# Access Compliance Report

## Public Rights-of-Way

Intersection ID: 24241	Main Street: KANFER_CT	Cross Street: PIMA_COTTON_DR	Location: NW
ADA ID: 814083AA7BEB	Ramp Type: BlendTrans2	Initial Pass/Fail: Pass	Overall Compliance: No
		Severity Score: 10.25

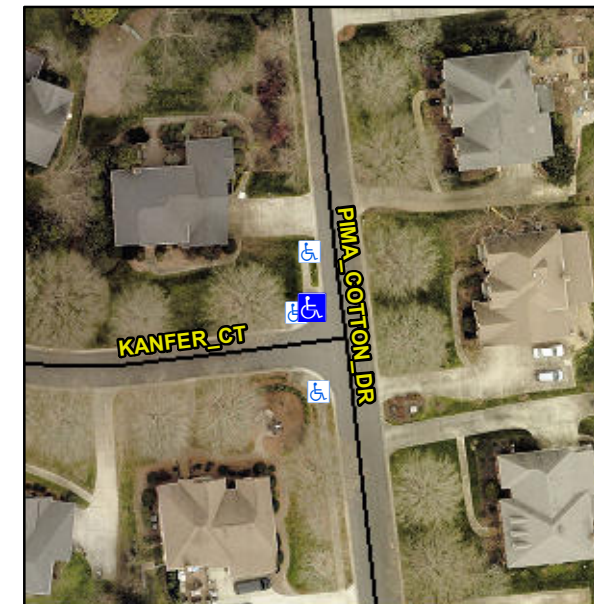
Compliance	Description	Data	Compliance	Description	Data
N/A	Ramp Length (in)	96.0	Yes	BlendTrans Slope (%)	4.5
Yes	Ramp Width (in)	48.0	No	BlendTrans XSlope (%)	3.6
N/A	Flare Type LT	None	N/A	Flare Type RT	None
N/A	Flare Slope LT (%)	N/A	N/A	Flare Slope RT (%)	N/A
N/A	Flare Traversable LT?	N/A	N/A	Flare Traversable RT?	N/A
N/A	Landing Length (in)	N/A	No	DWS Provided?	No
N/A	Landing Width (in)	N/A	N/A	DWS Contrast?	No
N/A	Landing Slope (%)	N/A	N/A	DWS Length (in)	N/A
N/A	Landing X Slope (%)	N/A	N/A	DWS Full Width?	No
N/A	Landing Curb? (Y/N)	No	N/A	DWS Offset (in)	N/A
N/A	Shared Landing?	No			
Yes	Gutter Ponding?	No	Yes	Gutter Slope (%)	2.6
Yes	Gutter Lip Ht (in)	0.0	Yes	Gutter X Slope (%)	0.8
N/A	Painted X Walk1?	No	N/A	Painted X Walk2?	N/A
	X Walk 1 Direction	To E		X Walk 2 Direction	N/A
	X Walk 1 Width (in)	N/A		X Walk 2 Width (in)	N/A
	X Walk 1 Slope (%)	2.6		X Walk 2 Slope (%)	N/A
	X Walk 1 X Slope (%)	0.6		X Walk 2 X Slope (%)	N/A

**Remove & Replace Curb Ramp With Two New Directional Ramps or Equivalent.**

**R304.5.3, R305**
